## HISTORIC AND DESIGN REVIEW COMMISSION

### Agenda Item No: 35

**HDRC CASE NO:** 2015-164  
**ADDRESS:** 1111 S ALAMO ST  
**LEGAL DESCRIPTION:** NCB 747 (ST. BENEDICT'S SUBD), BLOCK 6 LOT 26 PLAT 9574/144 FILED 03-02-07  
**ZONING:** C2 H HS IDZ  
**CITY COUNCIL DIST.:** 1  
**DISTRICT:** King William Historic District  
**LANDMARK:** Elmendorf, Edward - House  
**APPLICANT:** Meredith Siegel/Sprinkle & Co. Architects  
**OWNER:** Frolic & Detour, LLC  
**TYPE OF WORK:** Rooftop addition  
**REQUEST:**

HDRC Case No: 2014-341  
Rooftop Addition to Liberty Bar  
April 15, 2015

01 Southeast Elevation  
1/8" : 1'-0"

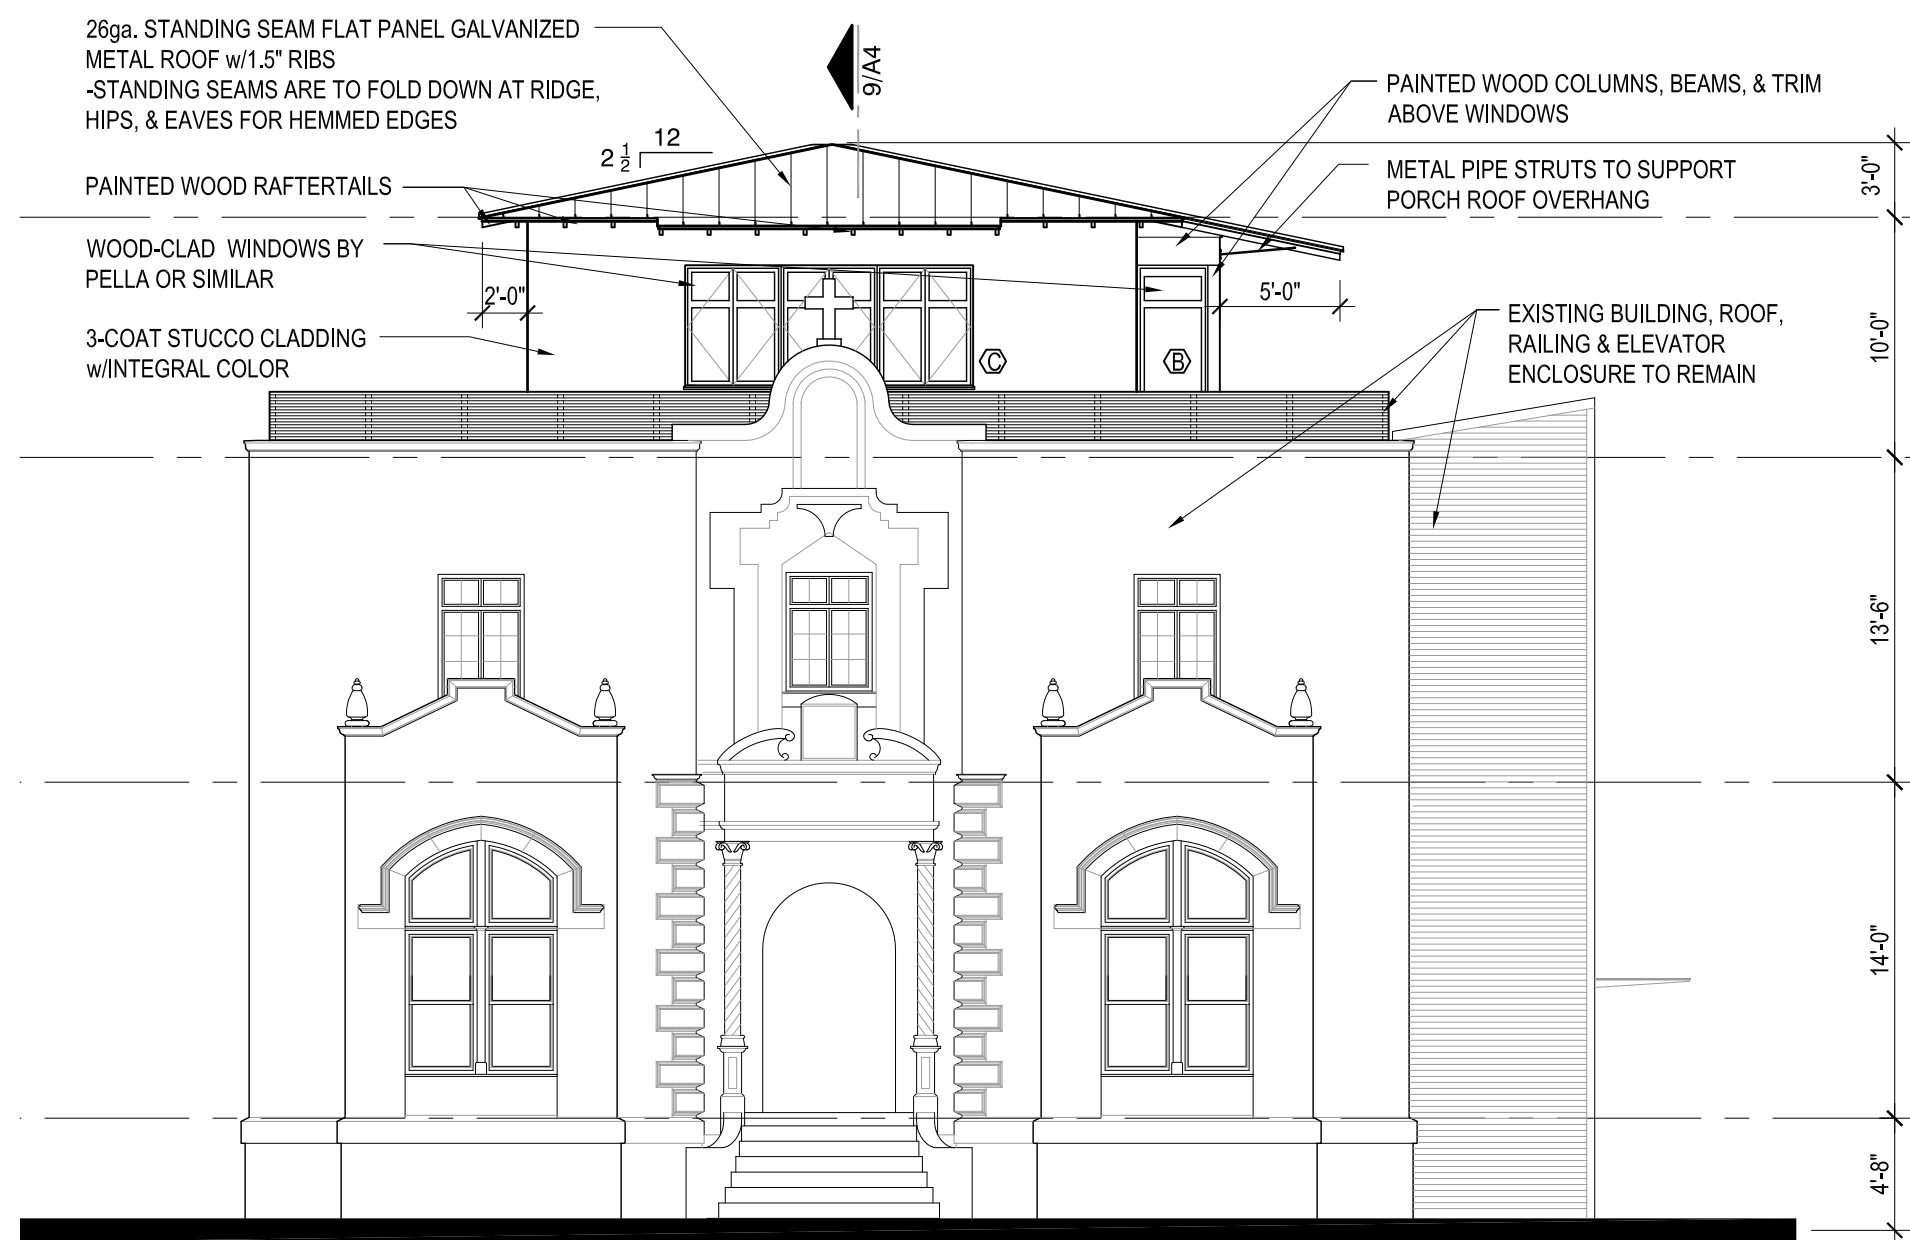
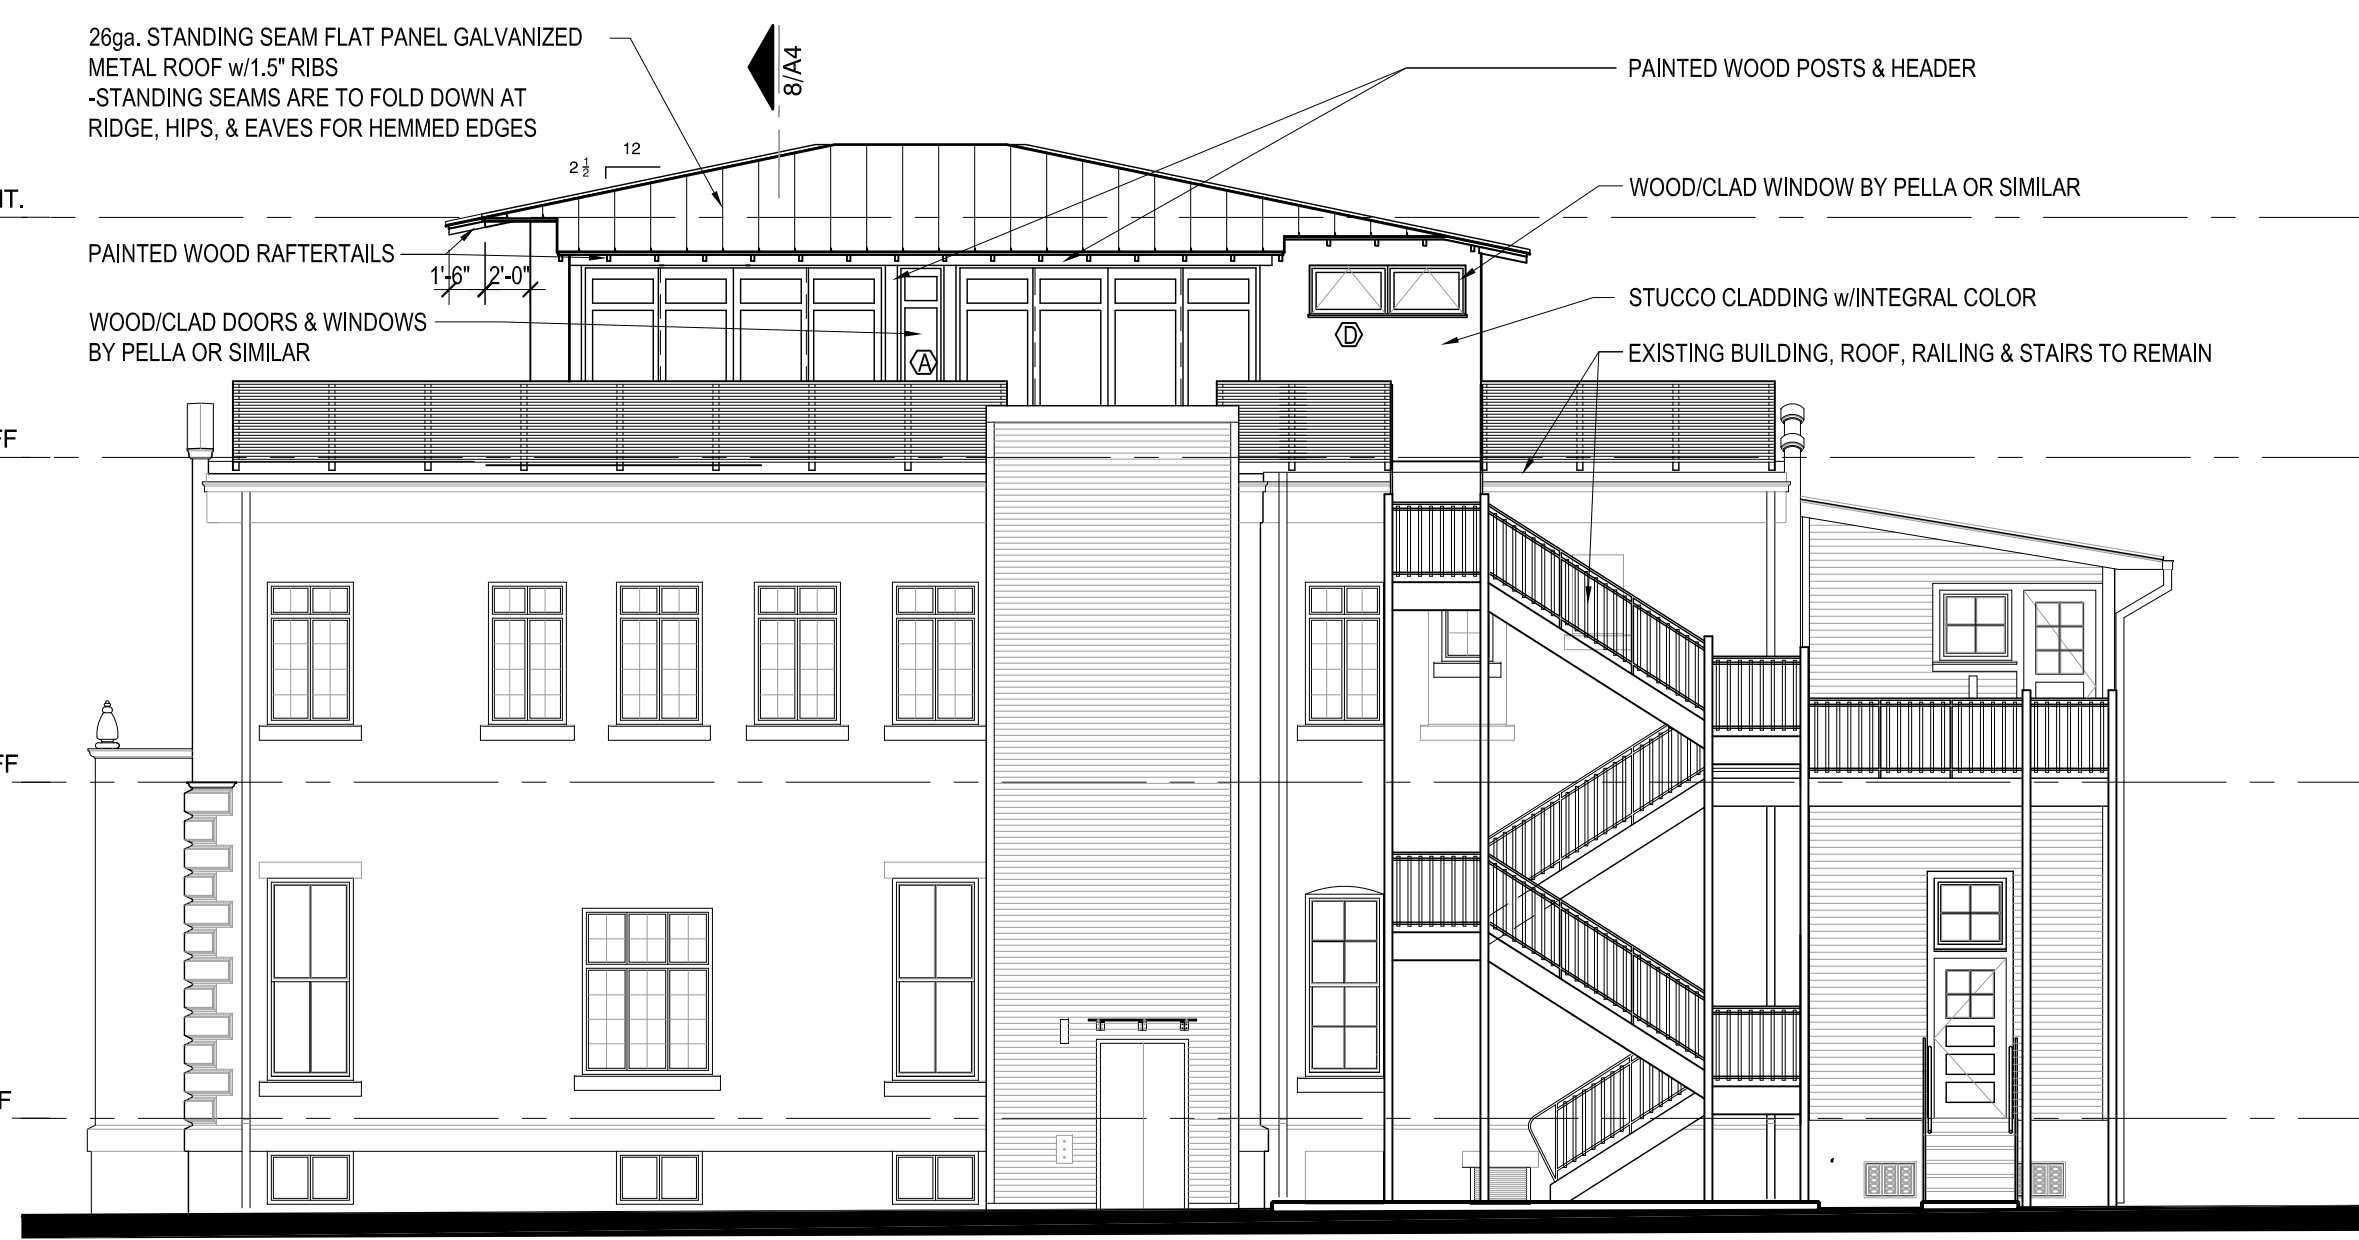
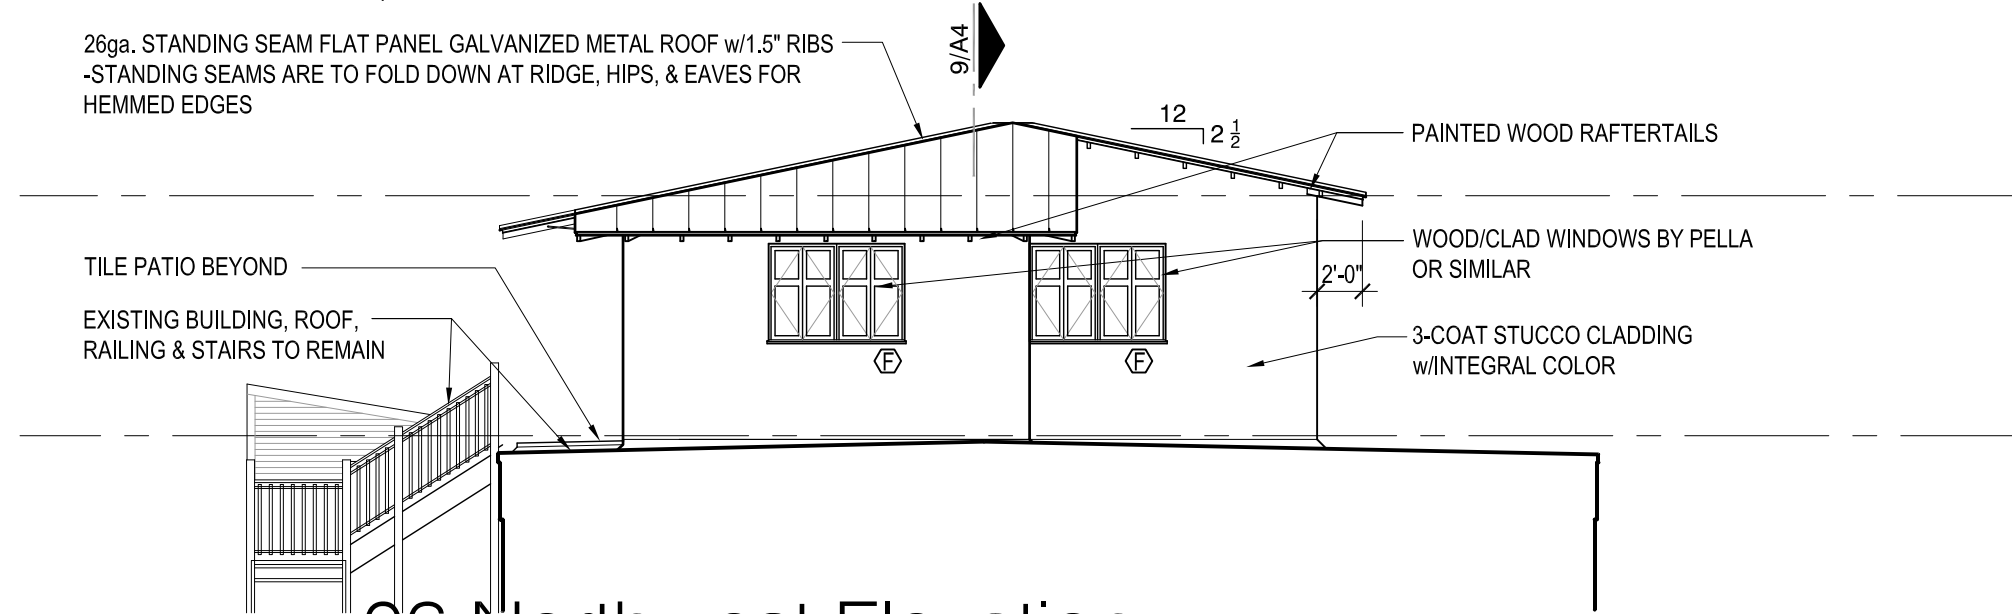
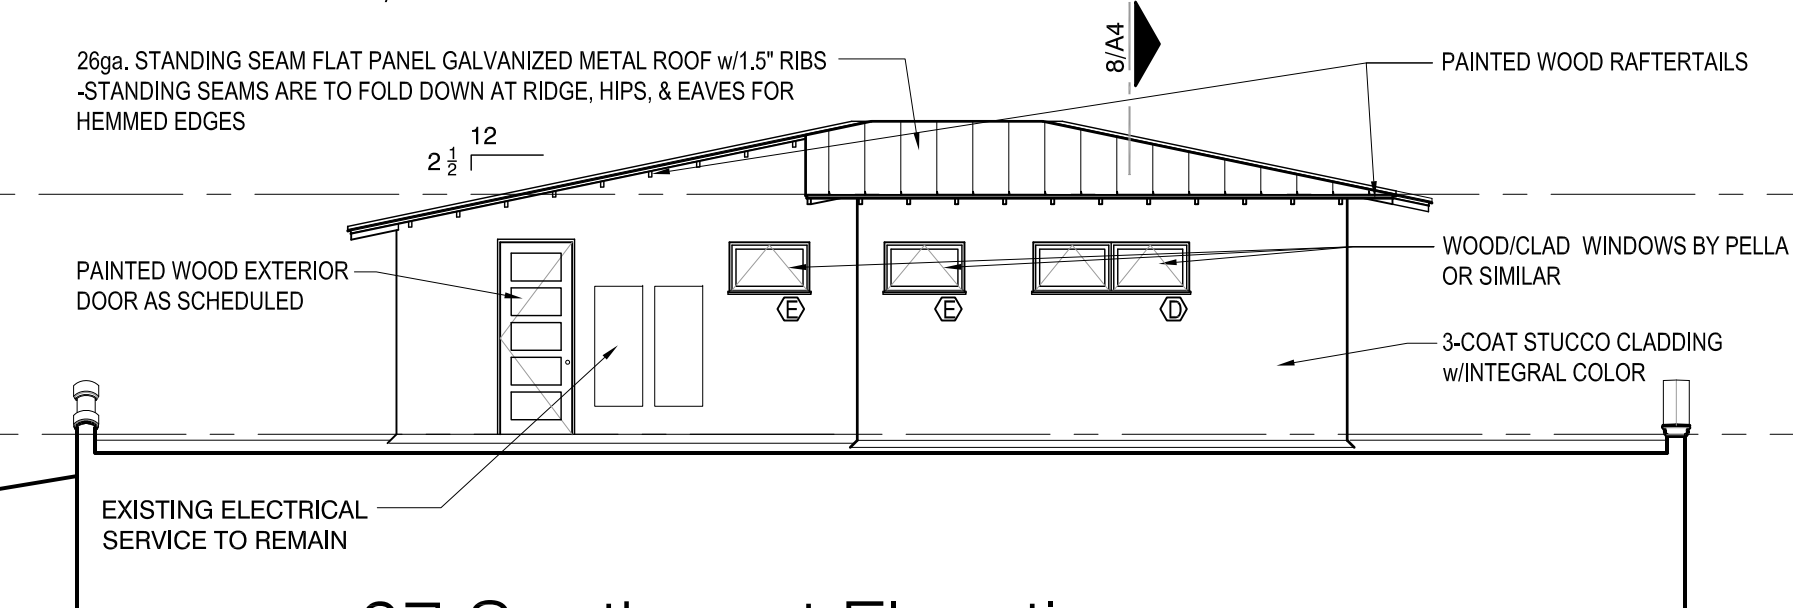
- a. The applicant received conceptual approval of the proposed rooftop addition on October 14, 2014, with the stipulations that the roof maintain a symmetrical form based and that the proposed standing seam metal roof meet the specifications for historic metal roofs, including the use of a double munched ridge seam.

- b. The historic St. Scholastica Convent / Liberty Bar building was constructed circa 1939 and features portions that predate the primary structure. The building features a strictly symmetrical façade with a central pediment entry. During the process of conceptual approval, both the HDRC and Office of Historic Preservation staff expressed concern over the asymmetrical design of the proposed addition's roof. It was recommended that the applicant redesign this aspect of the addition.

- d. The applicant has proposed for the height of the addition to be thirteen (13) feet tall. The approximate height of the existing, primary structure is approximately thirty-six (36) feet. The proposed height of the addition is consistent with the Guidelines for Additions 2.B.i which states that the height of additions should be limited to no more than 40 percent of the height of the original structure.

- e. According to the Guidelines for Additions 3.A.i, materials that match in type, color and texture should be used while including an offset or reveal to distinguish the addition from the historic structure. While the proposed addition's stucco facades do not match those of the original structure in regards to color, the difference in color provides the needed distinction and is appropriate. Staff finds that the use of standing seam metal roof, stucco façade, wood clad doors and windows and the metal pipe struts are consistent with the Guidelines.

- f. One of the stipulations included in the conceptual approval of this addition was the redesign of the roof line to a symmetrical form. The applicant has stated that the complete redesign of the roof line would be detrimental to the design given that the roof height would inevitably need to be raised to accommodate a new plate height of ten (10) feet. To compensate for this, the applicant has modified the overhands to promote a sense of symmetry at the front façade and has chosen a 1 – 1 ½" standing seam metal roof with folded over ribs / double munched at the ridgelines.

and eaves. The applicant has also taken steps to reduce the overall visual weight of the roof including using smaller dimension rafter tails and a knife-edge hemmed eave. While the applicant has taken numerous steps to improve the visual cohesiveness of the proposed roof line and façade, staff finds that the asymmetrical qualities of the proposed addition distract from the original, historic façade.

Staff does not recommend approval based on finding f. Staff recommends that the applicant meet with the Design Review Committee to find a solution regarding a complementary roof line.

This application for final approval from the Historic Design Review Commission follows conceptual approval granted on October 15, 2014. Last fall we submitted a design for an apartment over Liberty Bar, and it was recommended by staff and by the commission that the porch roof on the northeast side of the apartment be separated from the main roof over the structure for the purpose of maintaining a symmetrical façade facing Alamo St., and to reduce the perceived scale of the roof on the Sheridan St. façade.

Since that time we have tried several different designs and have found that designing two separate rooflines would be a detriment to the design and constructability of the project. In order to accommodate proper head clearance under the porch covering, while providing enough space to construct two physically separate roofs, the plate height of the apartment roof would have had to be raised over 10'-0" above finished floor. We think that is too high, and would create an undesirable visual presence at the street view. The double structure also created a much busier, more cluttered appearance above the Sheridan Street façade.

We now submit a new design that features one roof over the whole apartment. This roof will be clad in a 1 – 1 ½" standing seam metal with folded over ribs – or double-munching – at the ridgelines and eaves. We have modified the overhangs to promote the sense of symmetry at the Alamo St. façade, and have used smaller-dimension raftertails along with a knife-edge hemmed eave to lessen the bulk of the roof itself.
